# 12-16 Bent Street, Lindfield

## Flood Impact Risk Assessment

## 4. Response to CPHR/DPHI RFI

Table 2 CPHR/DPHI RFI Response

**APPROVAL**

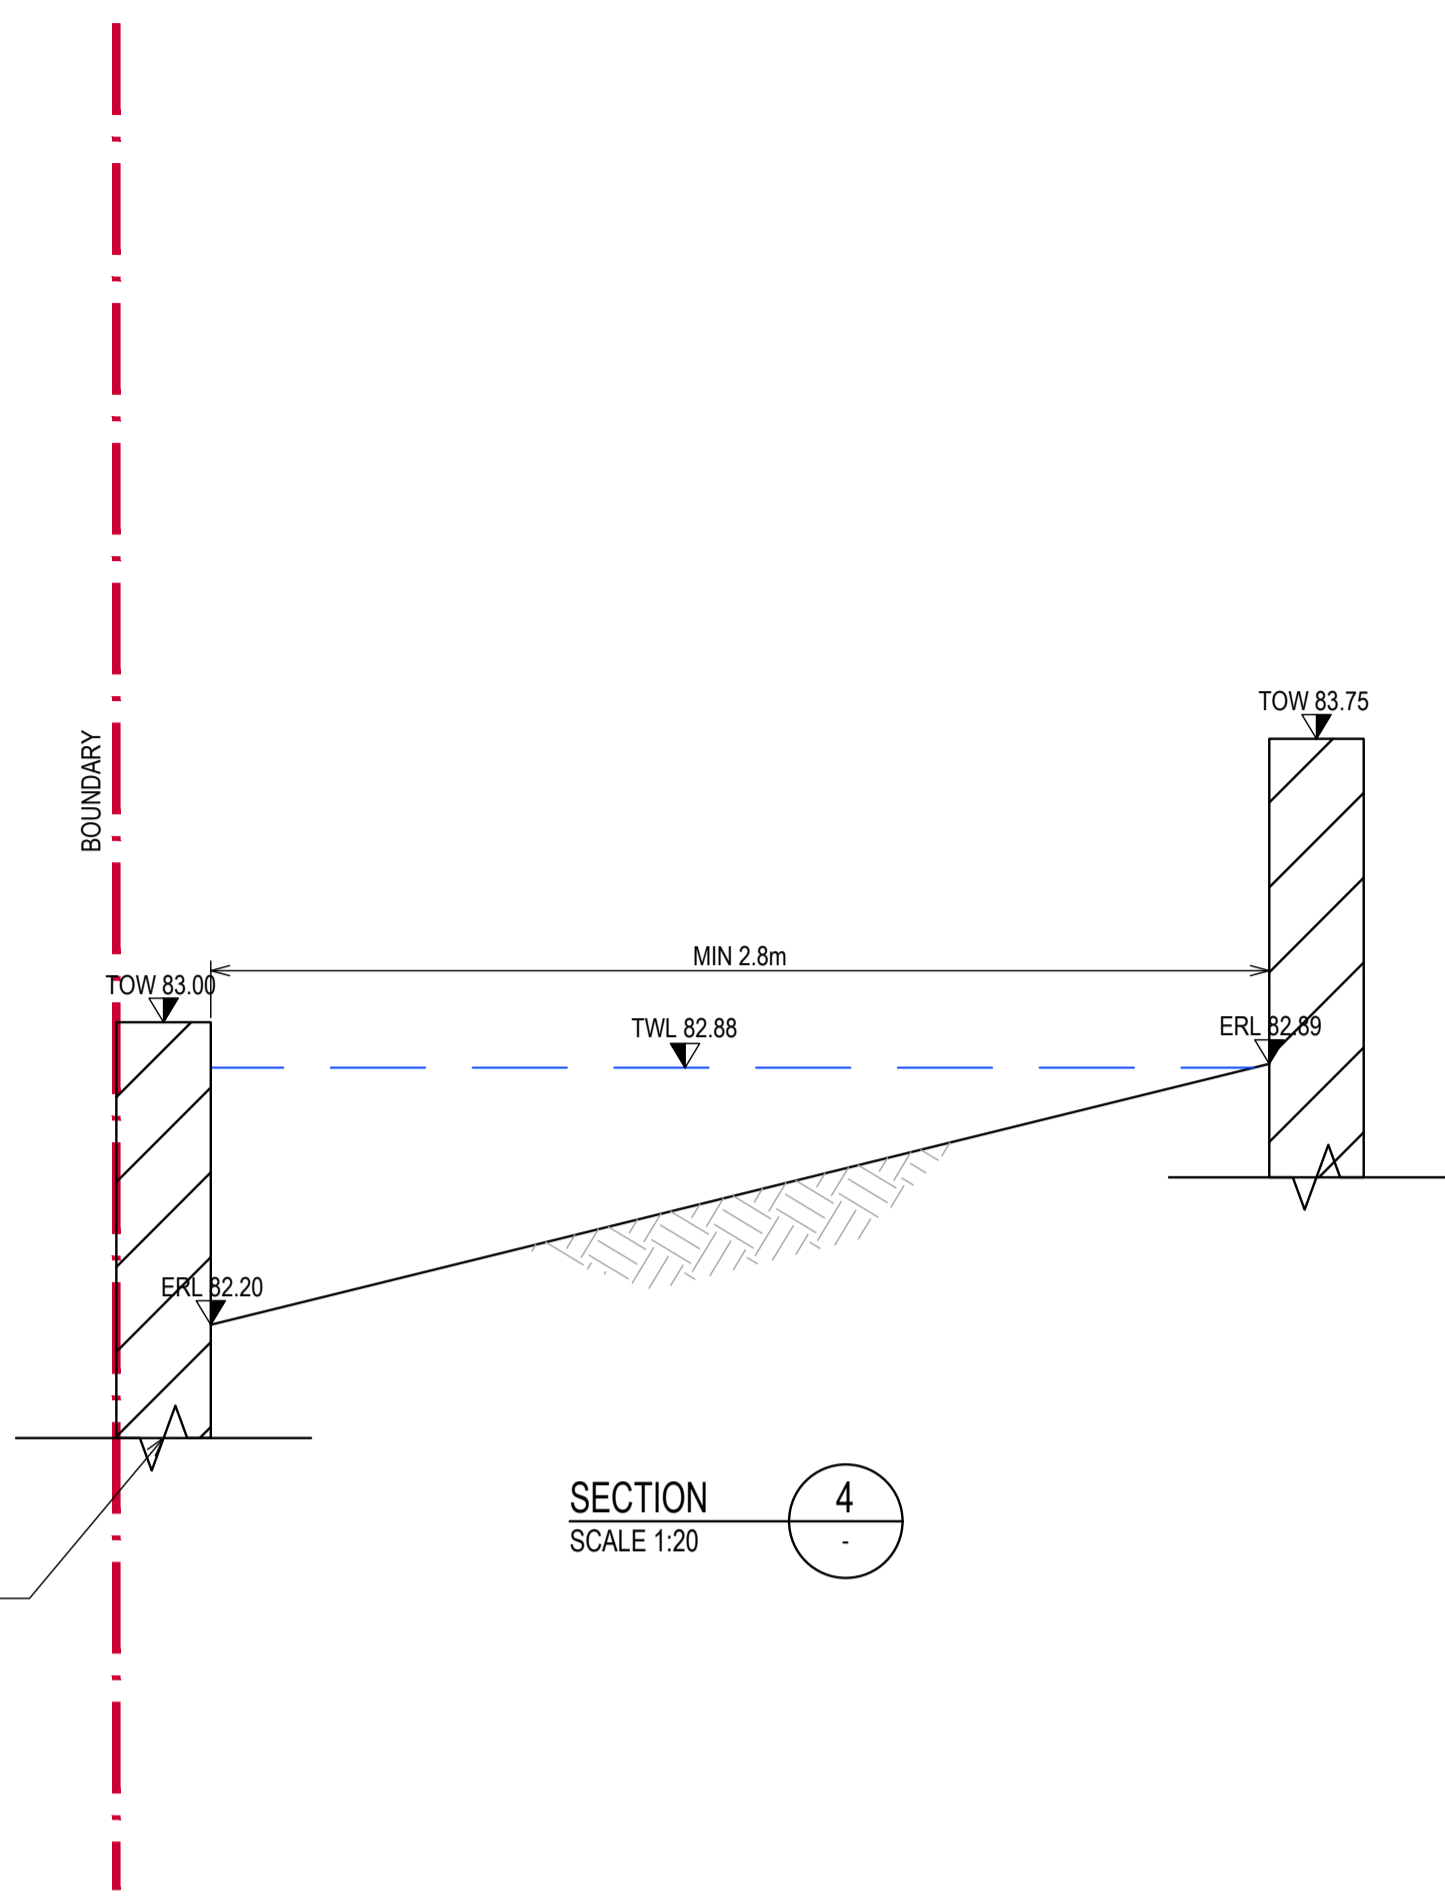
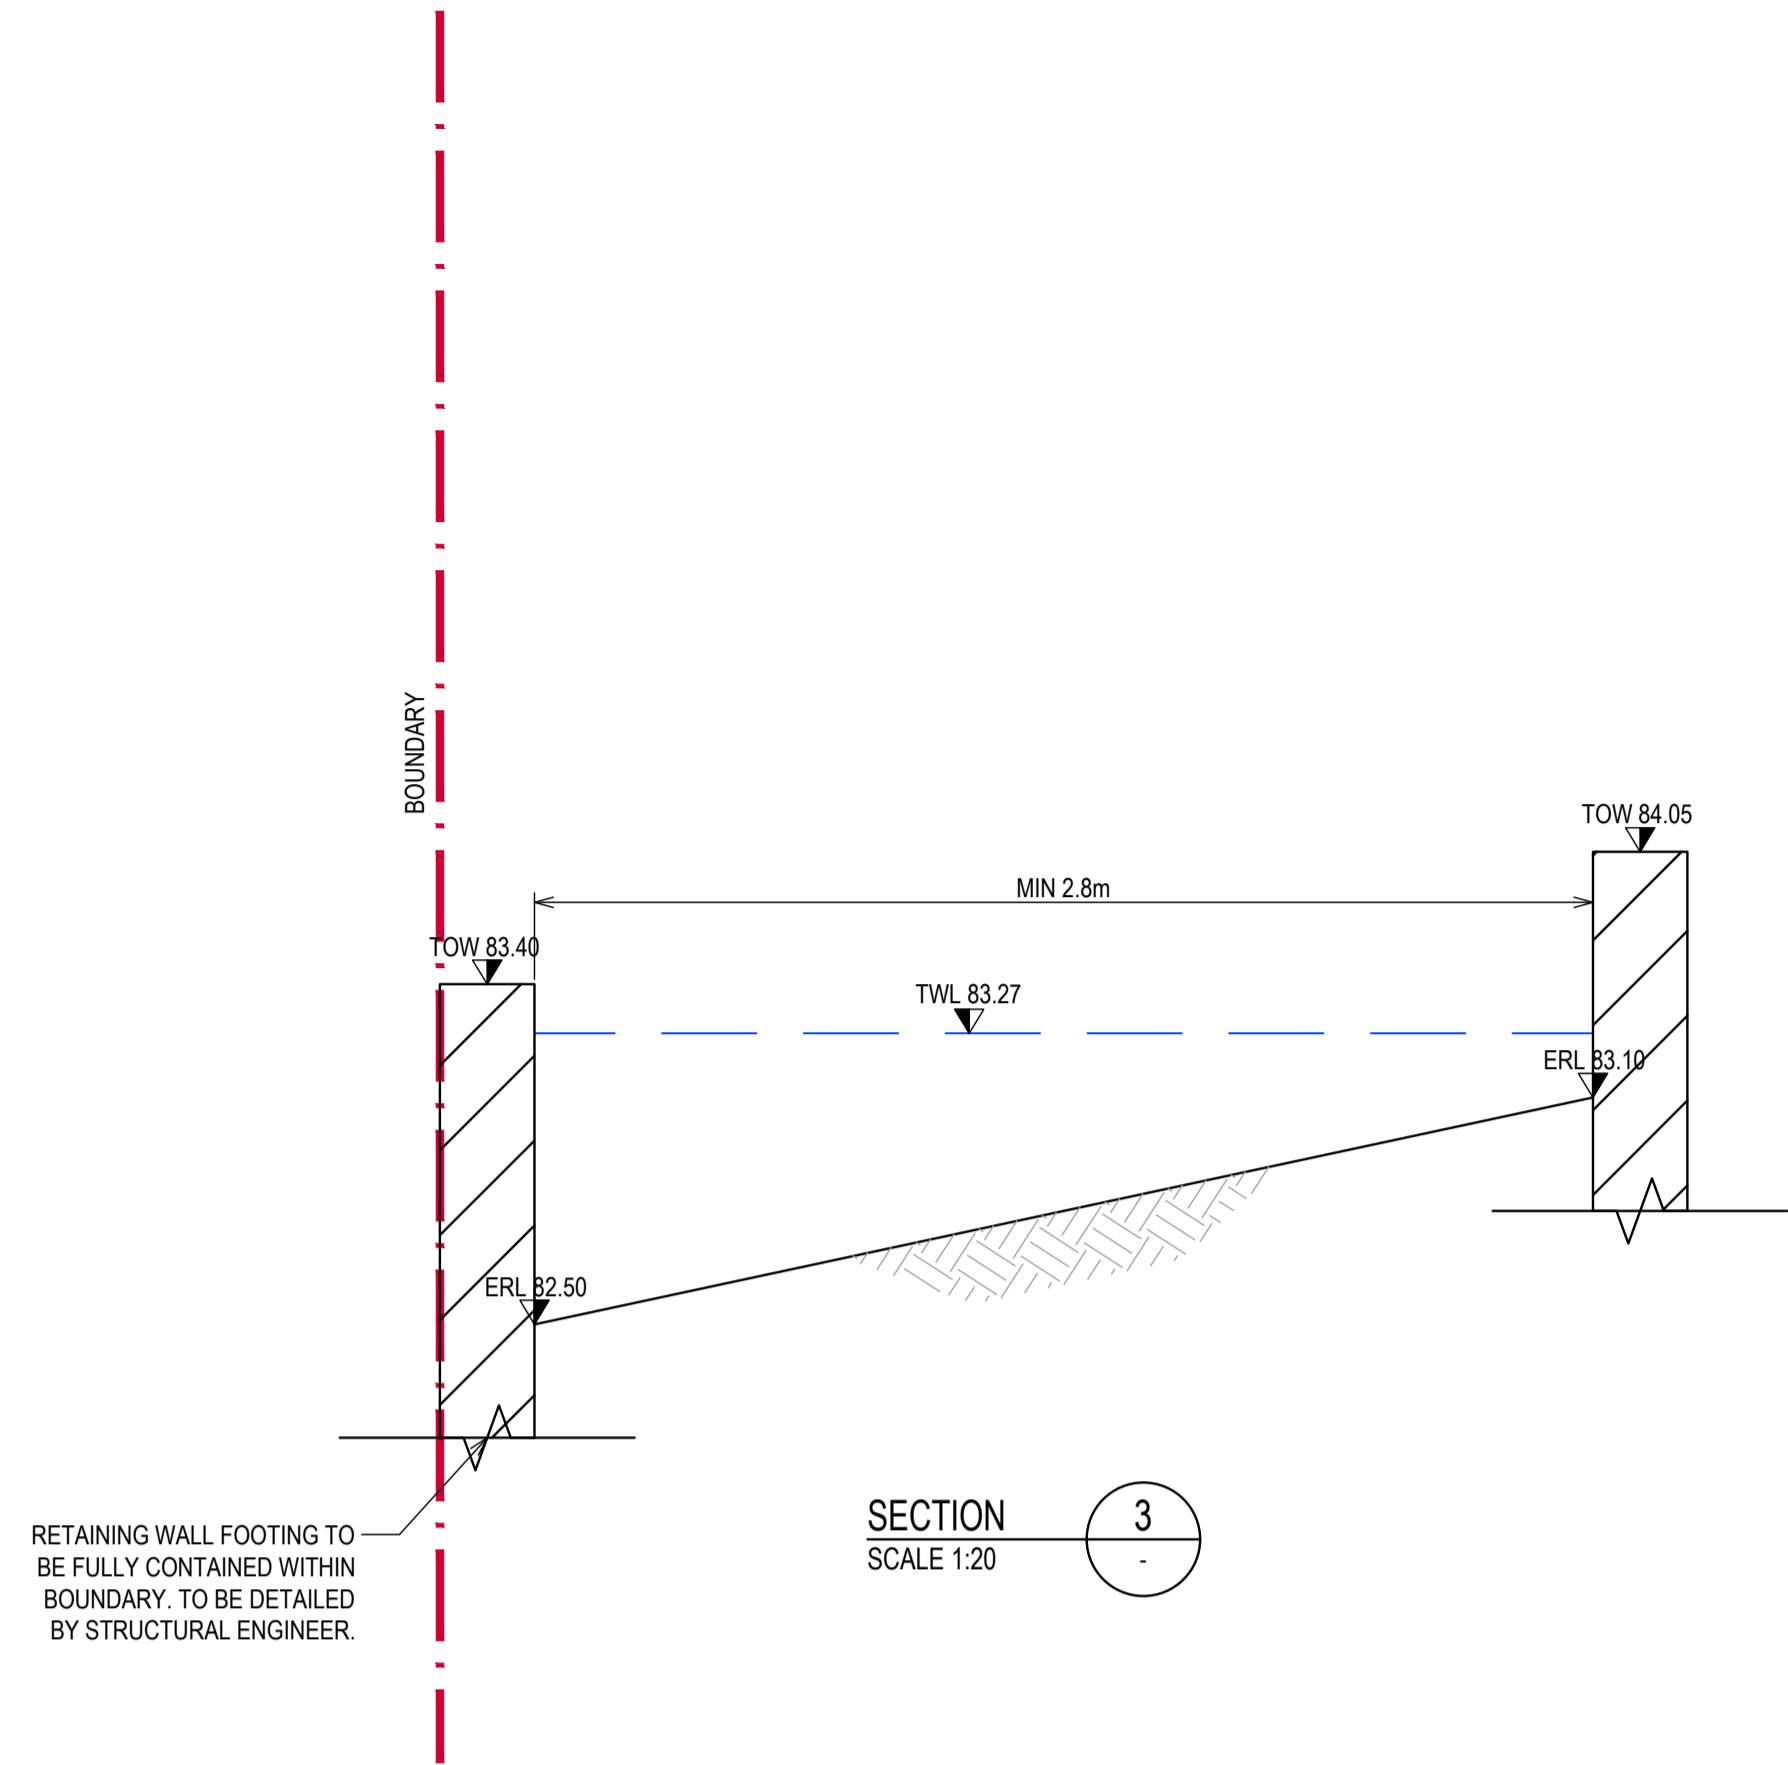
4.	The impact of climate change has not been considered	<p>The impacts of climate change on flood levels have not been modelled. Further, overland flow paths for the subject development are based on work undertaken for the neighbouring development that has been designed for the expected 1% Annual Exceedance Probability (AEP) flow in 2015 only and may not be adequate into the future.</p> <p><b>CPHR recommendation:</b></p> <ul style="list-style-type: none"> <li>• The impact of climate change on flood levels be included in the flood modelling</li> </ul>
	Extent and Timing	Pre-determination

Drawings CE201 and CE202 provide sectional views of the proposed overland flow path, including dimensions and water levels. As indicated in Drawing CE103, tree protection zones (TPZs) within the flow path make re-grading works impractical. Instead, it has been proposed for walls to be constructed to contain the runoff, with footings constructed to span over the TPZ.

4	<p>Climate change impacts have been modelled using the 2060 SSP2-4.5 scenario as part of this assessment and included as part of design considerations.</p> <p>Floodwaters are wholly contained within both the existing and neighbouring channels, with the exception of a single channel section in the adjoining property, where floodwaters overtop at depths &lt; 10mm.</p> <p><u>Refer to Section 2.2.2 and 2.4 for details.</u></p>
5	<p>The proposed overland flow path has been modelled using a 1D analysis of channel cross-sections that accurately represents the proposed geometry and vegetation.</p> <p>Proposed retaining walls have been shifted to sit entirely within the proposed site boundary.</p> <p><u>Refer to Section 2.3.3, 2.4 and Appendix E for details.</u></p>
